**Technical Service  
BULLETIN**

**WINDSHIELD WASHER FLUID LEAKING  
UNDER THE FRONT OF THE VEHICLE**

'05 – '07 Avalon

**BODY**  
**B0008-07**

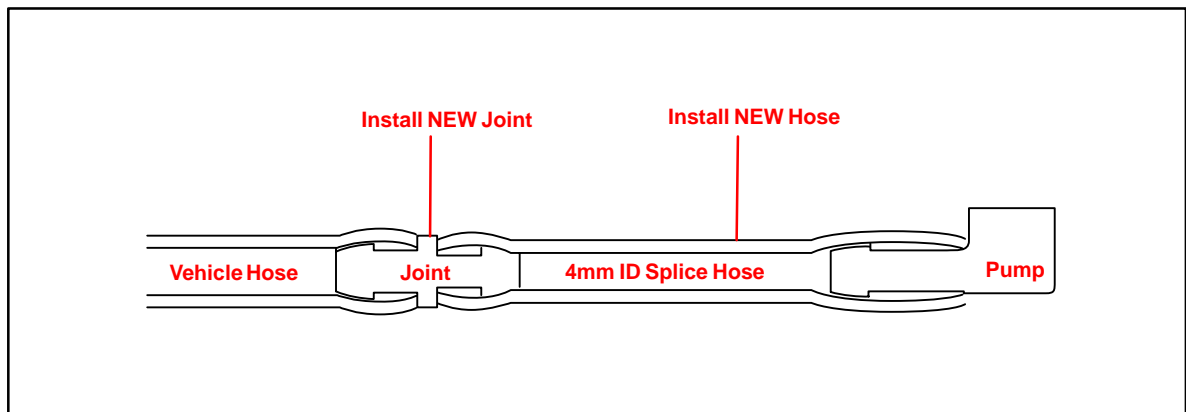
1. Remove the RH side plastic engine under cover (5 bolts and 3 push clips).

2. Install the NEW 40-mm (1.6-inch) long section of hose to the washer pump.

3. Install the NEW washer joint to the 40-mm (1.6-inch) long NEW hose.

Make sure that the smaller diameter end of the joint is attached to the NEW section of hose.
